City of Richmond
Urban Development Division

Report to Development Permit Panel

To: Development Permit Panel
From: Joe Erceg
Manager, Development Applications
Date: September 17, 2003
File: DP 03-233258
Re: Application by Nicole Cupic for a Development Permit at 7140 St. Albans Road

SITE PLAN B DPO3-233258

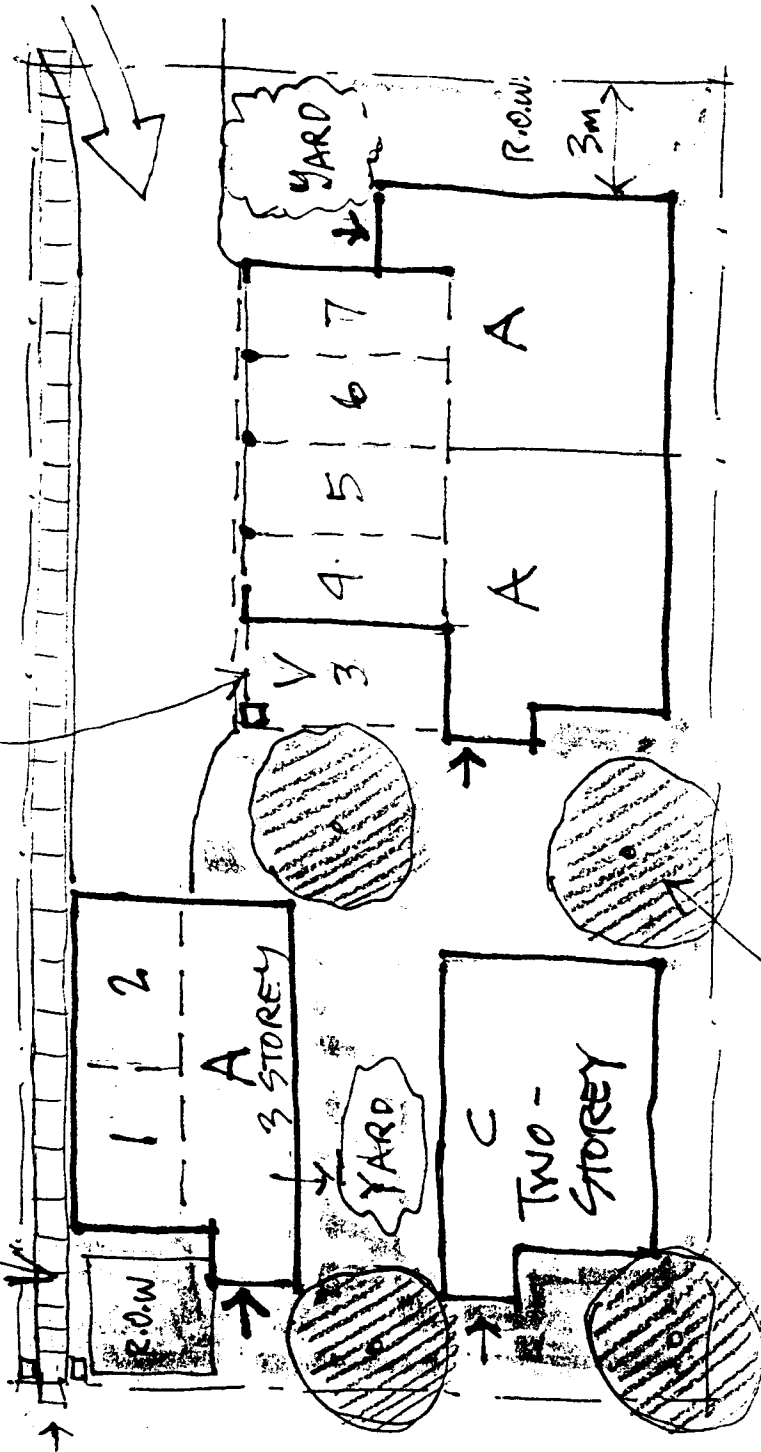
The decision to put two (2) parking spaces beneath each of the units results in an awkward site plan and a great deal of pavement. Putting all of the parking under the east building would help solve this problem; for example by introducing a “coach house” over a garage. This would then allow for replacement trees in the approximate location of the largest Willow tree that was removed.

The number of parking spaces could be reduced, since the bylaw requires only seven (7) spaces whereas nine (9) are provided. Reducing the parking or changing the site plan has the advantage of adding more green space and some two-storey buildings with living space at grade. Two examples of alternative site plans are shown on the attached sketches.

A 3 m x 4 m utility right-of-way (ROW) will be required in the north-west corner of the site. As a result, we recommend that the adjacent unit be allocated a yard in a different location (see sketches attached).

The applicants have not made the changes to the site plan.
